From: Ronald Uy <ronald.uy@aucklandcouncil.govt.nz>
Sent: Monday, 19 November 2018 11:23 AM
To: Hannah Thomson
Subject: RE: SUB60315199- Remiger Road

FURTHER RESPONSE TO SECTION 92 REQUEST
Client: Ray Nicklin and Desma Nicklin
Location: 53B Remiger Road, Puhoi
Council Ref: SUB60315119

LOTS 1 - 8 BEING
PROPOSED SUBDIVISION OF
LOT 8 DP 208981, LOT 5 DP 198556
LOT 1 DP 179794, ALLOTS 32,35,54A &
PT ALLOTS 30,31,36 PARISH OF PUHOI

Figure 1: Diagram showing extent of modelled and actual watercourses within Lot 3 of subdivision

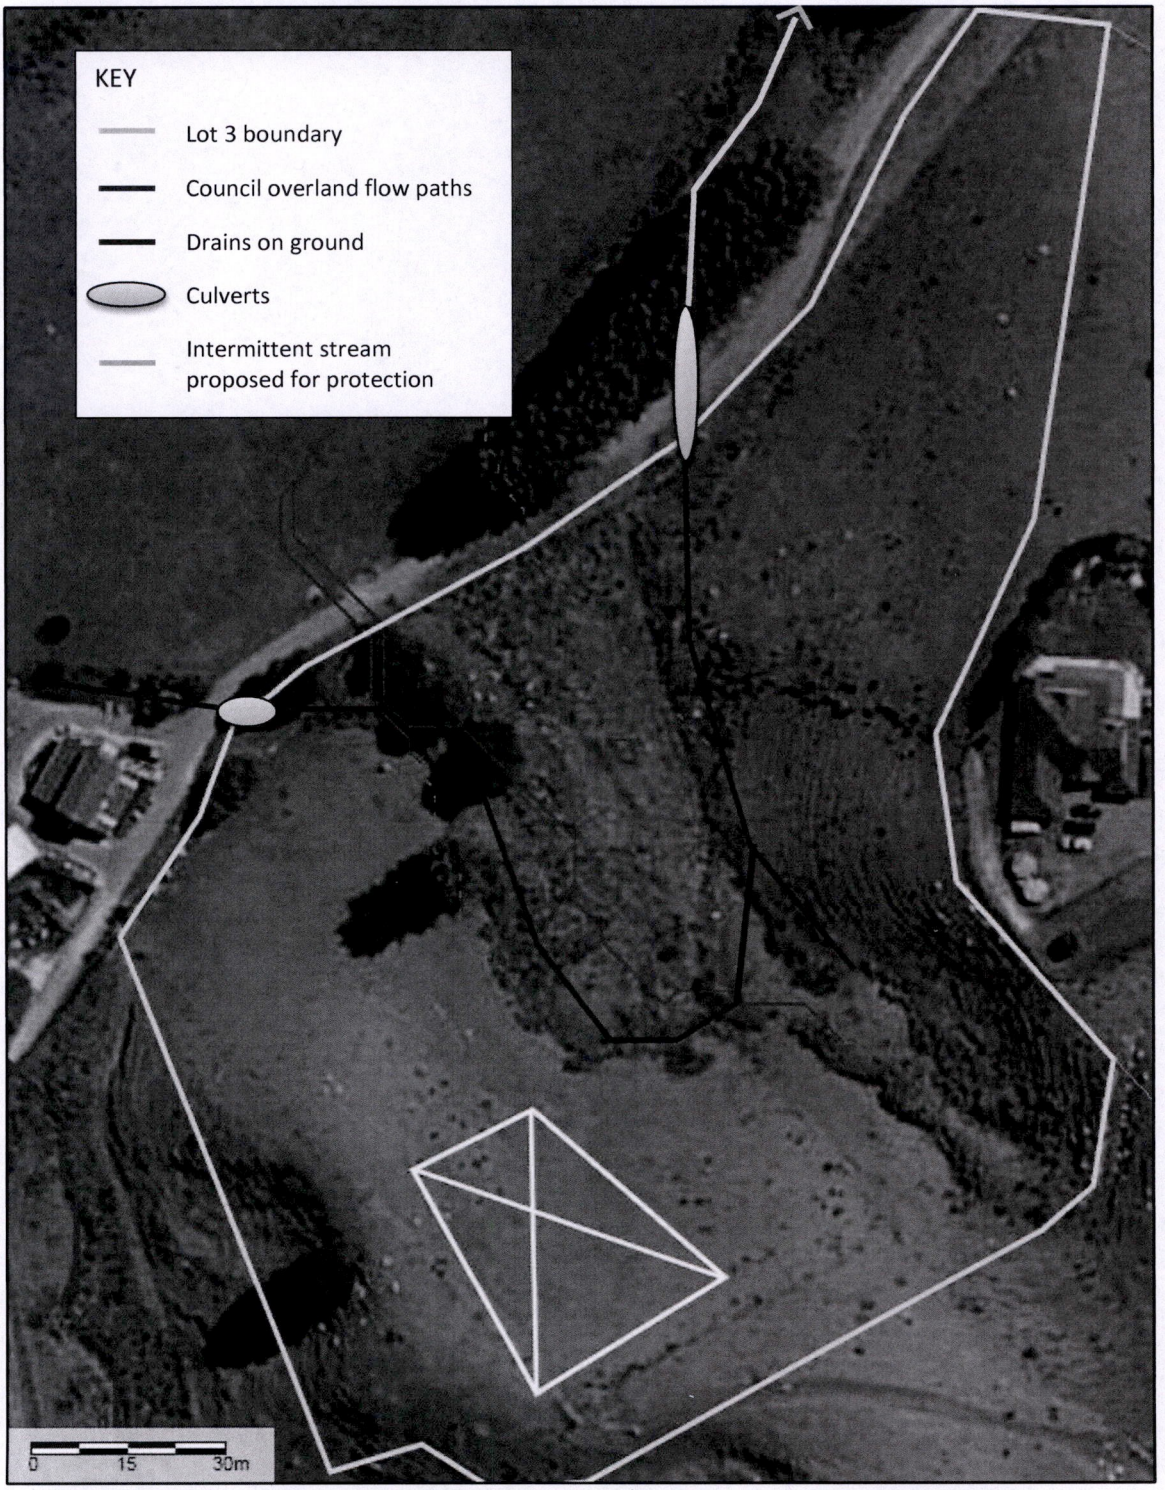
As shown in **Figure 1**, defined channels are present in parts of Lot 3, however these are not located in identified overland flow paths, and appear to have been dug to drain the surrounding wetland areas for more suitable farmland. The drains are also clearly visible on Google Earth aerial photos. These drains pass beneath the main farm access in locations where no overland flow paths are present, to join natural streams further north on the site.

In summary, the watercourses present within Lot 3 are classified as ephemeral and have questionable naturalness given the straight nature and surrounding wet ground, as well as modified hydrology around the main farm access. In our experience, drains have not been classified as natural watercourses where

they are not located along indicative overland flow paths, and this interpretation is consistent with the artificial watercourse definition in the AUP. Rule 7.14.2.5 of the Rodney Plan does not appear to apply to farm drains, and wetlands are also not required to be protected under this rule. We therefore remain of the view that there is no provision in either the Rodney Plan or AUP to require protection of the Lot 3 watercourse.

ORIGINAL SCALE 1:10000	ORIGINAL SIZE A3	REVISION NO	R5
DATE SEP 2017	CAD REFERENCE 40320-1200	SHEET NO 1 OF 2	1200
DIRECTORY SYNERGY 40320 Drwgs Schemes		JOB NO	40320

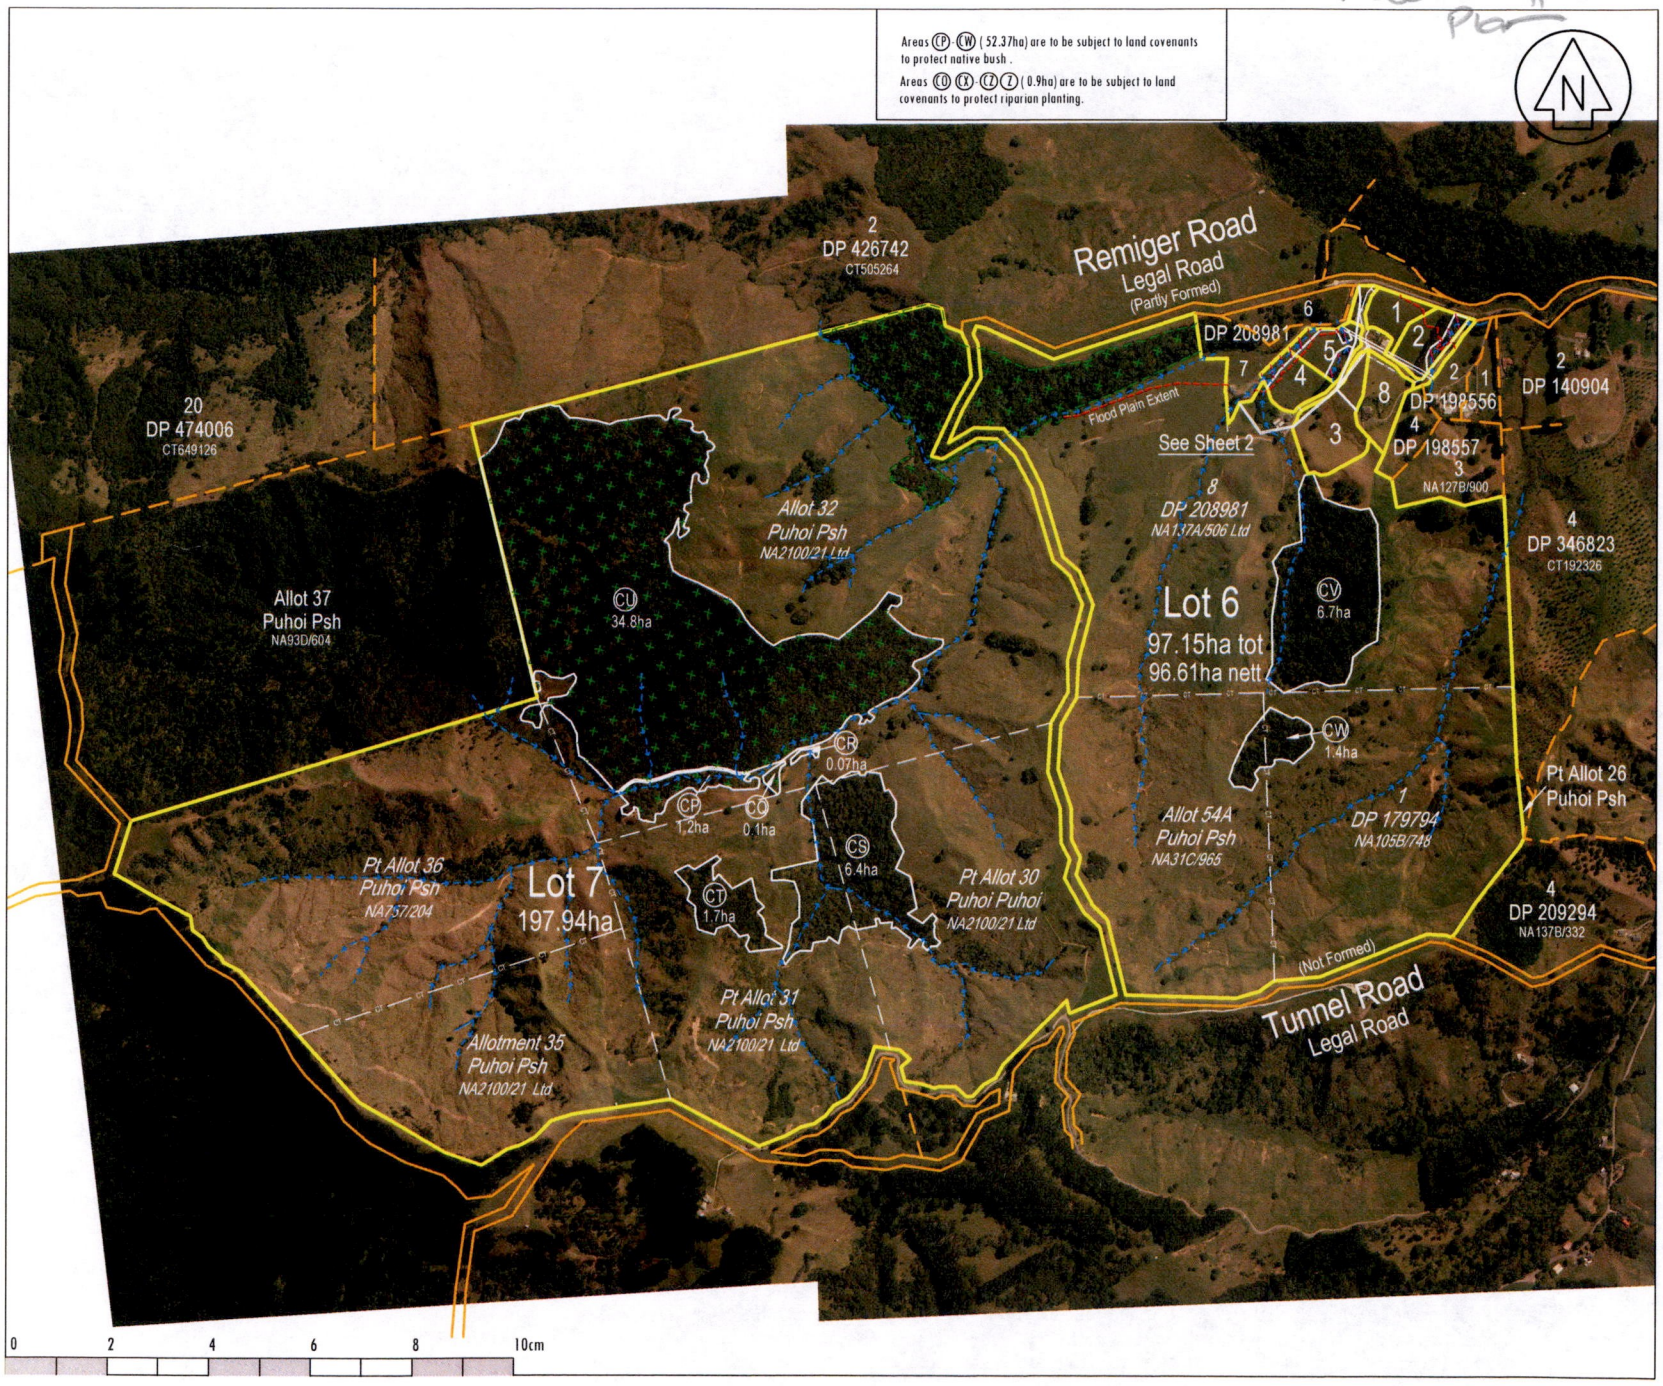
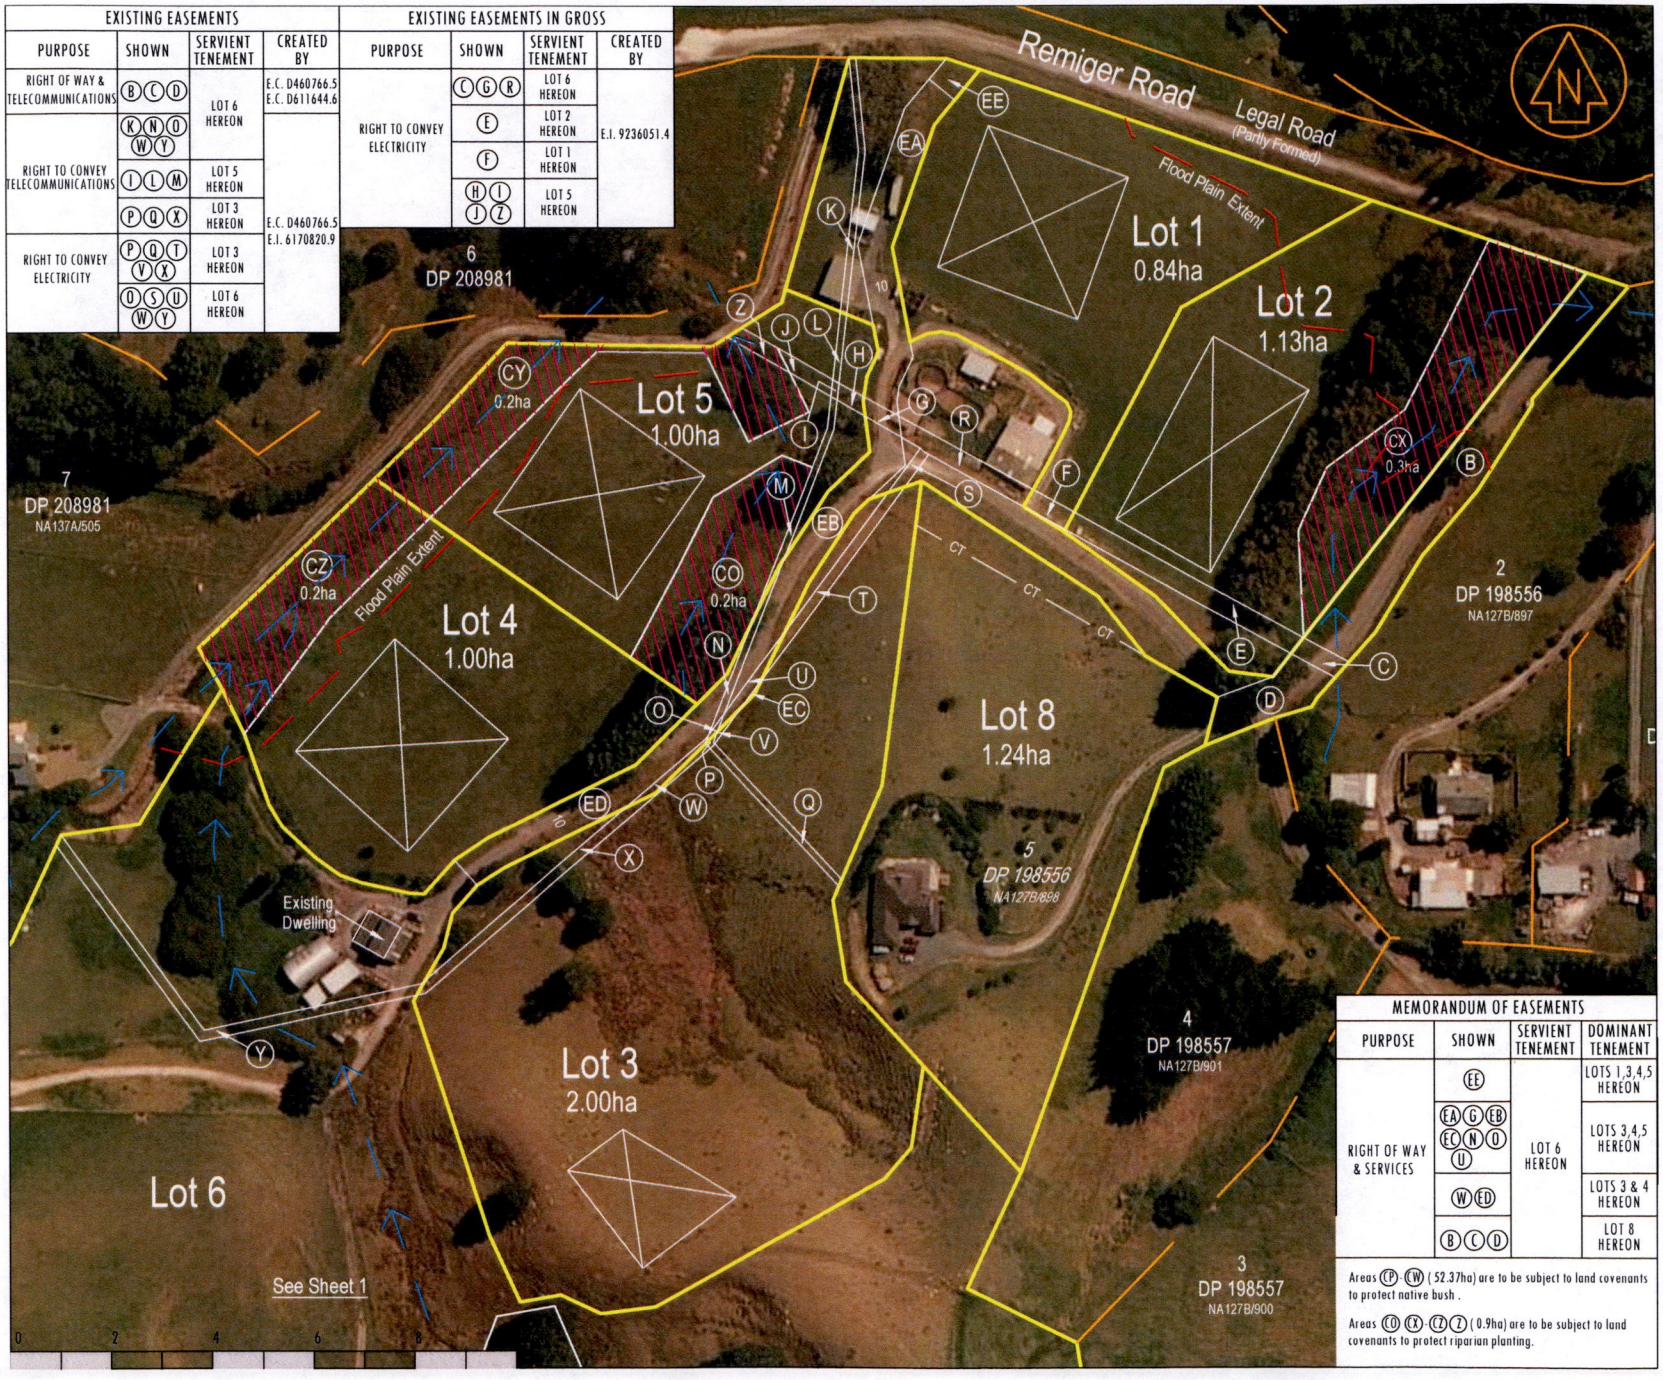
The proposed access to Lot 1 is shown as ROW easement 'EE' on the updated Scheme Plan attached. This access will be achieved by turning off from the road crossing before the main ROW continues south to the other sites.

I have updated the riparian planting plan as per the suggested changes below, and also to cover the new planting area requested by Council's ecologist. This updated report is attached. The new planting area (Area 'CO') is shown on the Scheme Plan referenced as R5, previously sent to you on 9th May.

In terms of access, while the change is better I am still concerned about either Lot 1 or Lot 2 having direct access onto Remiger Road. Apart from the character issues, the area is heavily affected by floodplains (which is an sisue we need to consider under s7(h) and s106 RMA) and on the face of it there doesn't appear to be any reason why the ROW (A etc) cannot be used. Council's Development Engineer has confirmed that no new conditions would be required if both lots used the ROW vs direct access onto the road.
